Technical Service Bulletin: tsb100295

Aftercooler Vent Hose Removal and Aftercooler Cover Change

This Technical Service Bulletin is to inform the field of a product change for all QSK45 and all QSK60 engines aftercooler water air vent systems, and an aftercooler cover change.

Old Type 1 Installation with Aftercooler Vent Line Locations

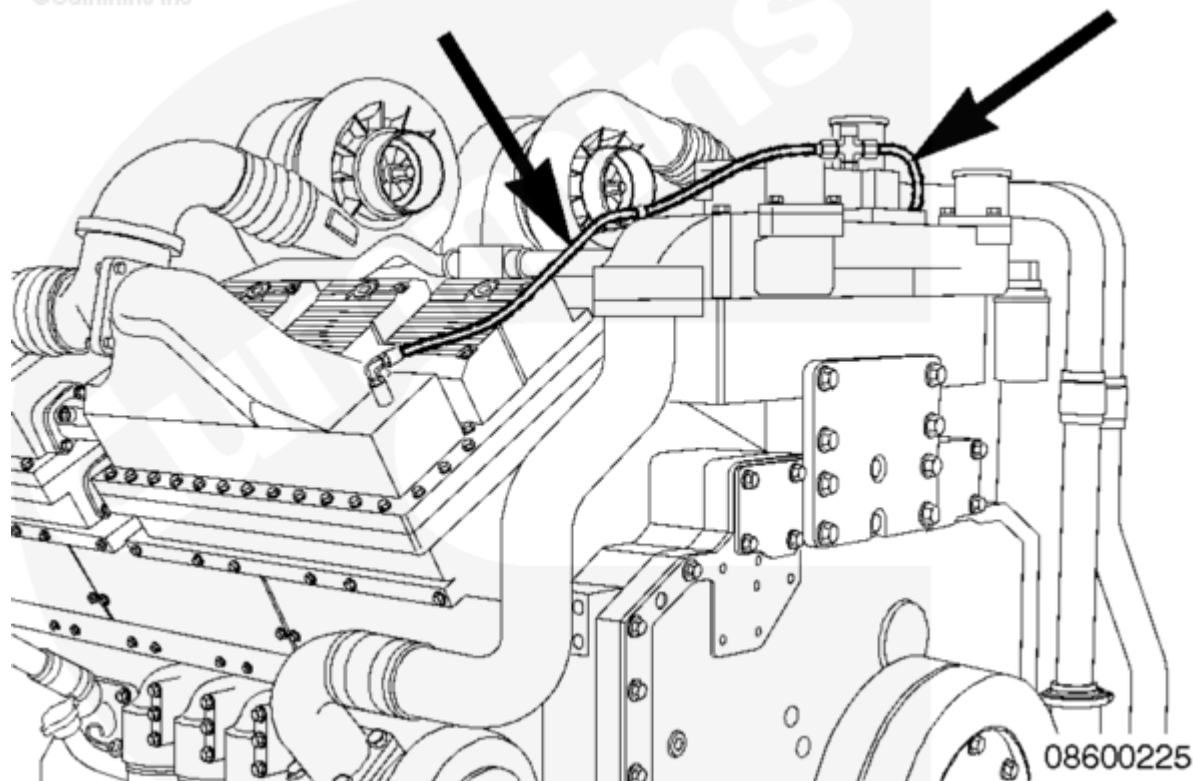
A product change has been introduced to remove the water air vent line system from the QSK product range. This will mean there are now three variations of air vent line installation.

- Old Type 1 - This consists of the original set up with vent lines installed
- Old Type 2 - Vent lines removed and aftercooler core vent outlets plugged (Introduced July 2002).
- New Type - Vent outlet removed from aftercooler cores and new aftercooler covers introduced. Engine serial number first for the QSK60 was 33156143, built - 17th of March 2004, and for the QSK45 was 33156082, built 8th of March 2004.

Aftercooler Cover Changes

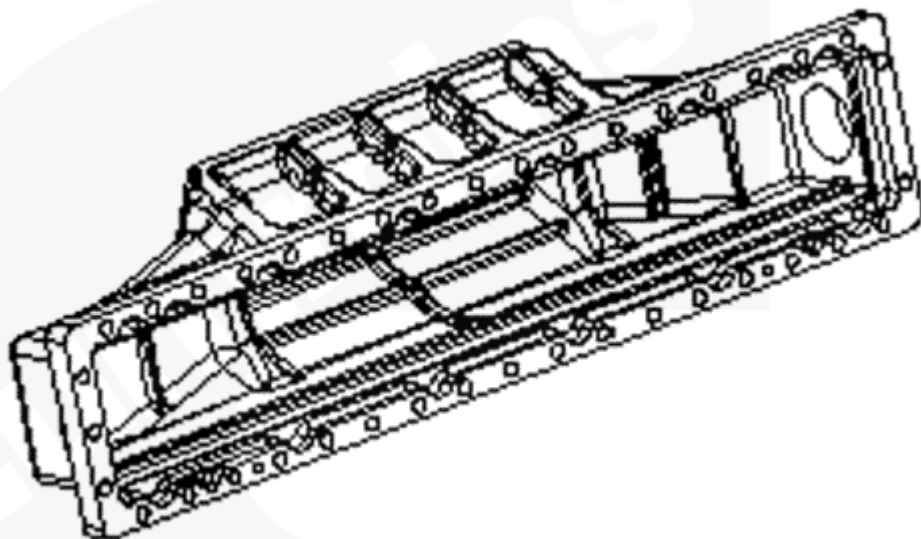
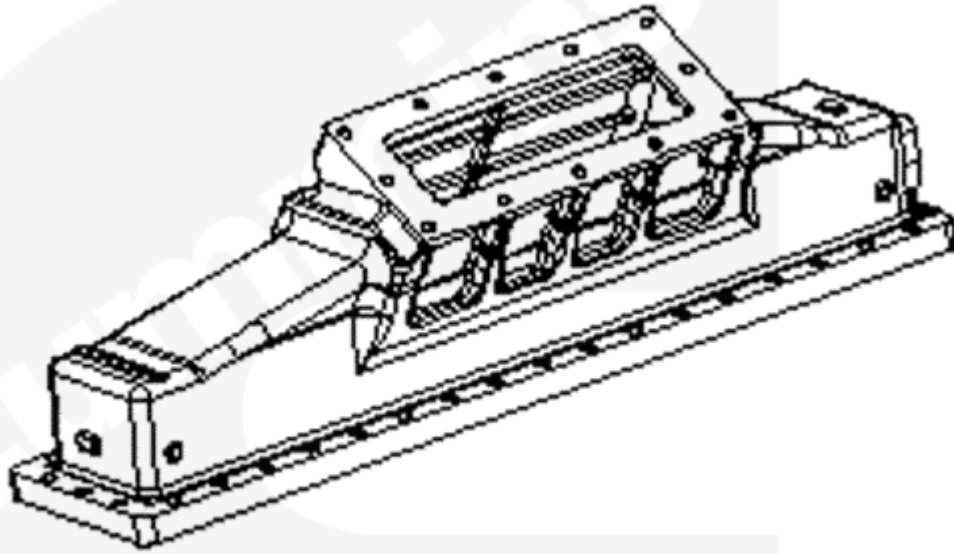
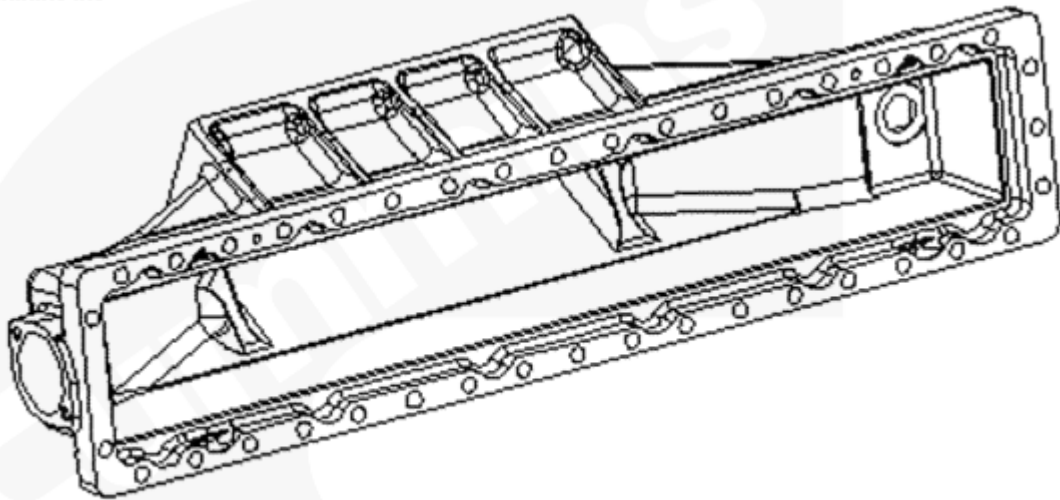
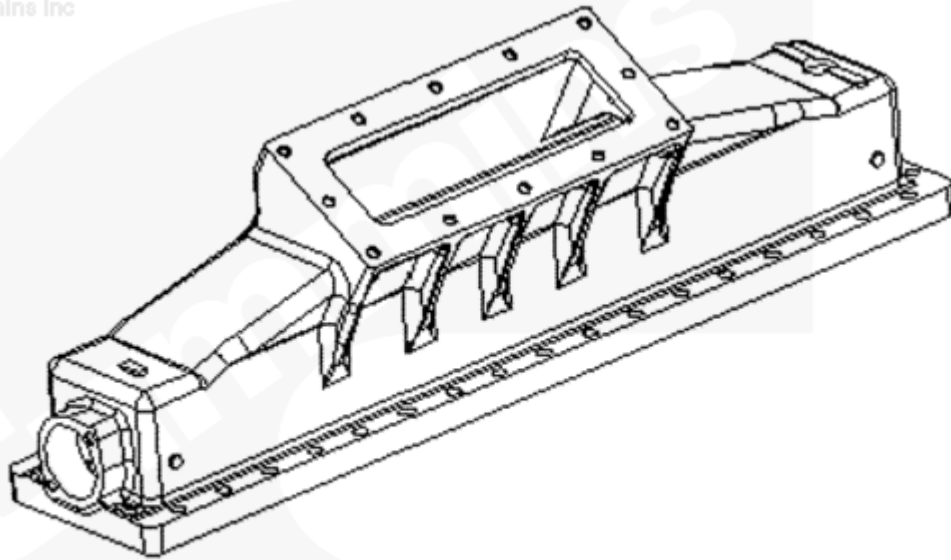
This change was made to increase the durability of this component. Improvements have been made by adding a number of strengthening ribs in the critical internal and external areas.

If you are fitting a NEW type aftercooler core to an OLD type 1 or OLD type 2 engine, do NOT attempt to plug the vent outlet hole in the aftercooler cover. A NEW type aftercooler cover must be installed.
